**CASE:** PAR230033
**EXHIBIT:** Site Plan
**DATE:** 6/8/2023
**PLANNER:** B.Bernardino

☑ Meeting ☐ Comment Agenda ☐ Final

SITE PLAN - OPTION 1 | SCALE: 1"= 50'-0"

PROJECT:
TENANT IMPROVEMENT
STORAGE FACILITY
BOAT AND TRAILER PARKING

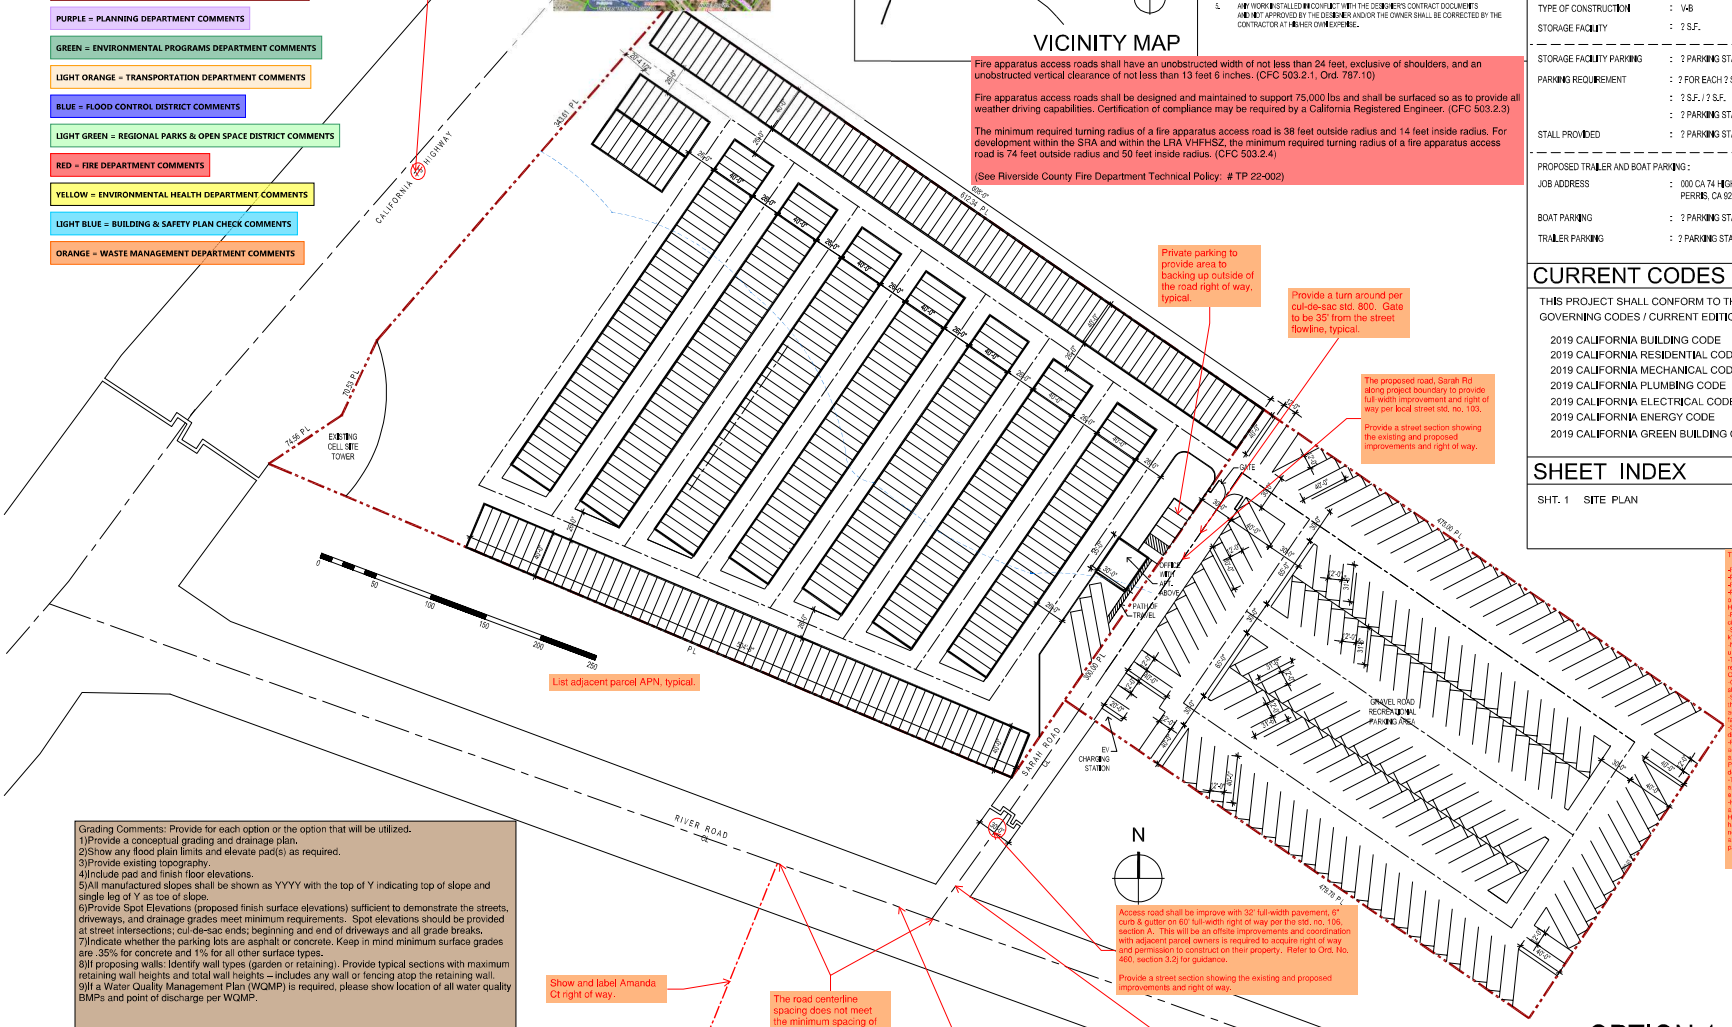
HWY-74 is a County maintained road designated as a 6-lanes expressway in the general plan (see red & white line on image to the right). Improve Hwy-74 with 55' half-width AC pavement on 92' half-width right of way per 6-lanes expressway std. no. 85. Access Restriction along Hwy 74 per std. 114. Project to provide access easement for the existing cell tour.

Provide a street section and show the existing and proposed improvements and right of way.

There is a County project in design phase for a raised median project along the centerline of Hwy-74.

Fire apparatus access roads shall have an unobstructed width of not less than 24 feet, exclusive of shoulders, and an unobstructed vertical clearance of not less than 13 feet 6 inches. (CFC 503.2.1, Ord. 787.10)

Fire apparatus access roads shall be designed and maintained to support 75,000 lbs and shall be surfaced so as to provide all weather driving capabilities. Certification of compliance may be required by a California Registered Engineer. (CFC 503.2.3)

The minimum required turning radius of a fire apparatus access road is 38 feet outside radius and 14 feet inside radius. For development within the SRA and within the LRA VHFHSZ, the minimum required turning radius of a fire apparatus access road is 74 feet outside radius and 50 feet inside radius. (CFC 503.2.4)

Private parking to provide area to backing up outside of the road right of way, typical.

Provide a turn around per cul-de-sac std. 800. Gate to be 35' from the street flowline, typical.

The proposed road, Sarah Rd along project boundary to provide full-width improvement and right of way per local street std. no. 103.

Provide a street section showing the existing and proposed improvements and right of way.

List adjacent parcel APN, typical.

Transportation applies to all design options:
-Provide TIA and VMT for the project
-Provide a conceptual grading exhibit
-Provide a preliminary drainage exhibit
-Provide a topo survey exhibit showing existing onsite improvements and street improvements along Hwy-74 and River Rd.
-Provide a truck turning template for onsite circulation and entered thru driveways.
-Show and label existing power poles and its sizes in kV. Power pole sizes 33.8 kV shall be underground.
-New Gates shall be located 35' from the street's ultimate flowline.
-The project is in very high fire area and it may require both primary and secondary access; refer to Ord. No. 460, section 3.2.
-Centerline intersections of streets and driveways shall be at 90 degrees.
-Show all existing and proposed drainage facilities that will handle the storm water of the site and its adjacent streets. Provide Q10 and Q100 for these facilities.
-Show street slope, contours, elevations and direction of flow.

-Please show and label the required off-site public access road dedication by map or instrument number and date of recordation on a separate index map. Please provide the hard copy of said off-site dedication.
-The engineer/applicant has a responsibility to show and label the line point(s) and to provide the emergency overflow facility for each sump.
-HWY-74 is a County maintained road designated as a 6-lanes expressway in the general plan. Improve Hwy-74 with 55' half-width AC pavement on 92' half-width right of way per 6-lanes expressway std. no. 85. Provide AC pavement transition from east and west project boundaries to join existing edge of pavement.

Grading Comments: Provide for each option or the option that will be utilized.
1)Provide a conceptual grading and drainage plan.
2)Show any flood plain limits and elevate pad(s) as required.

3)Provide existing topography.
4)Include pad and finish floor elevations.
5)All manufactured slopes shall be shown as YYYY with the top of Y indicating top of slope and single leg of Y as toe of slope.

6)Provide Spot Elevations (proposed finish surface elevations) sufficient to demonstrate the streets, driveways, and drainage grades meet minimum requirements. Spot elevations should be provided at street intersections; cul-de-sac ends; beginning and end of driveways and all grade breaks.

7)Indicate whether the parking lots are asphalt or concrete. Keep in mind minimum surface grades are .35% for concrete and 1% for all other surface types.

8)If proposing walls: Identify wall types (garden or retaining). Provide typical sections with maximum retaining wall heights and total wall heights – includes any wall or fencing atop the retaining wall.

9)If a Water Quality Management Plan (WQMP) is required, please show location of all water quality BMPs and point of discharge per WQMP.

Show and label Amanda Ct right of way.

The road centerline spacing does not meet the minimum spacing of 660' per std. no. 114. Realign or move the new road and align with Amanda Ct.

Additional improvements on River Road to add a 12' left turn lane centered on street centerline.

Access road shall be improve with 32' full-width pavement, 6" curb & gutter on 60' full-width right of way per the std. no. 106, section A. This will be an offsite improvements and coordination with adjacent parcel owners is required to acquire right of way and permission to construct on their property. Refer to Ord. No. 460, section 3.2) for guidance.

Provide a street section showing the existing and proposed improvements and right of way.

Realign the new road to approach River Rd at 90 degree. Provide 50' tangent between the ultimate flow line location of adjacent street and the beginning of curve.

Provide RW corner cut per std. 805.
